Seattle Design Commission

MINUTES OF THE MEETING

July 20 2006

Projects Reviewed

20 July 2006 Project Central Waterfront Master Parks Plan

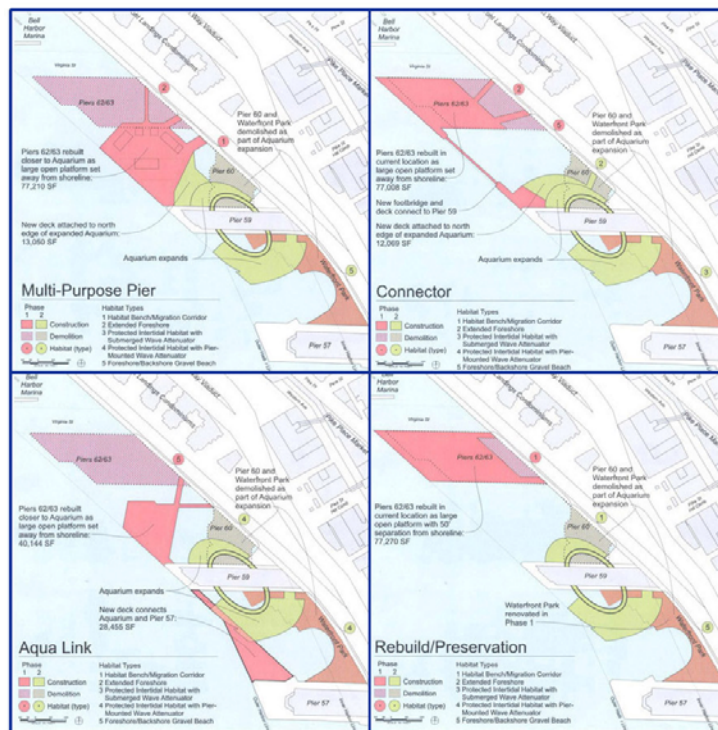
- On funding, is habitat restoration a requirement of the proposal to go forward and what would its budget be? It seems to be the most developed part of the design.

- We are not increasing in any way
- A lot of these schemes create pockets of water surrounded by pedestrian paths, have you figured out how to make these bodies of water functional? To make these spaces a positive?

- The connector scheme would give the pedestrian experience a feeling of being out over the water.
- The rebuild, preservation alternative is the least interesting because the location of the pier is related to railroad, industry, and shipping. As a park space it does not have relevance and the schemes that break from this are the Aqua Link and Multipurpose structure because they relate to current urban form and are much more interesting. While the park should not be designed solely around Summer Nights at the Pier, it is a unique venue that relates to the natural environment of the city as opposed to something like KeyArena that is not unlike any other arena in the world. Sinking millions of dollars into it seems less relevant to creating a unique city. Designing for the venue but also accommodating everyday uses seems to respond to the more interesting possibilities.

- Is a gravel beach a viable option?
 - Yes, but it would take a lot of fill and a lot of maintenance. The cost would possibly be \$8 to \$10 million. This kind of beach is called a perch beach, common in other parts of the U.S. but not on the west coast.

- A gravel beach would make a dramatic difference in public perception of this city on the water.
- We are trying to leverage the definition of over water coverage. What is missing in this discussion is how this relates to traffic, pedestrian routes,

20 July 2006 Project Capital Industries

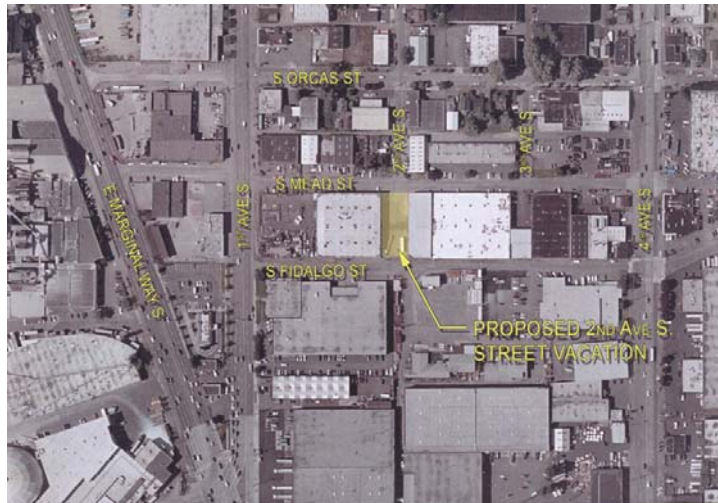
- Sees this as easy project to support. Off-site benefit makes sense but would like to see it go to improvements in public realm
- Yes, agree. Public benefits need to do more. Maybe trees on site in Right of Way on 1st Ave.?

- Already done with rebuild after fire
- Any trees need to be more than what is otherwise required. Would prefer to see all of the funds now targeted for the college go to street and park improvements in the public realm since these are more permanent.

- Yes, want to see some street trees on 1st Ave. Think contribution should fully go to street and park, not South Seattle Community College.
- Is there any interest by BINMIC to improve pedestrian access in the area?

- Some, but thought South Seattle Community College was a better idea
- Why \$20,000 as a public benefit? Make sure it does something.
- Would like to see benefit related to industrial use but more physical, i.e. signage and wayfinding.
